## Urgent Notice for Users of Multidata's Treatment Planning Systems

Multidata has determined that its treatment planning system will accept blocks that are entered improperly (in a manner other than that specified in the user manual). When a block is entered improperly, the results may differ from those expected by the user.

Fig. 1: Incorrect crossing block outline

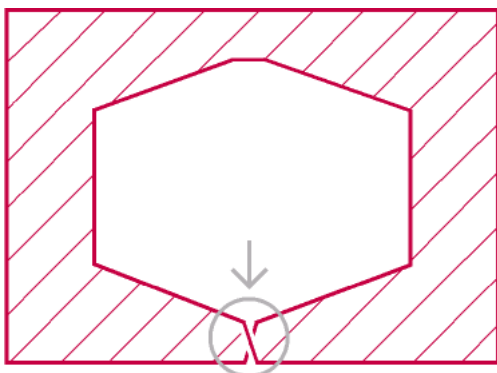
**In BEV, regardless of the direction in which the block is entered or the shape of the block, when the block outline crosses itself (see Fig 1, left) an improper block is created (i.e. not a true polygon.)**

These improper blocks will produce substantially higher values (50 to 500% for MU or TIME-ON) than what one would expect by partially blocking an open field.

To assure that data entry defining an aperture shape is correct, one should use two blocks (Fig 4). Note that outlines of different blocks may overlap; however, if only one block is used, it is essential to verify that the block outline does not cross itself (Fig 3).

Fig. 3: Safe aperture definition with a single continuous line

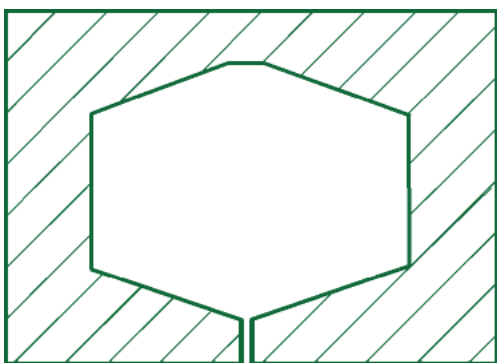
**Whenever this solid line is present, the data entered and plan results should be verified to determine that the results are valid and as expected.** Please note that some properly entered blocks, including those that extend over three sides of the field (Fig 3), will also display this solid line.
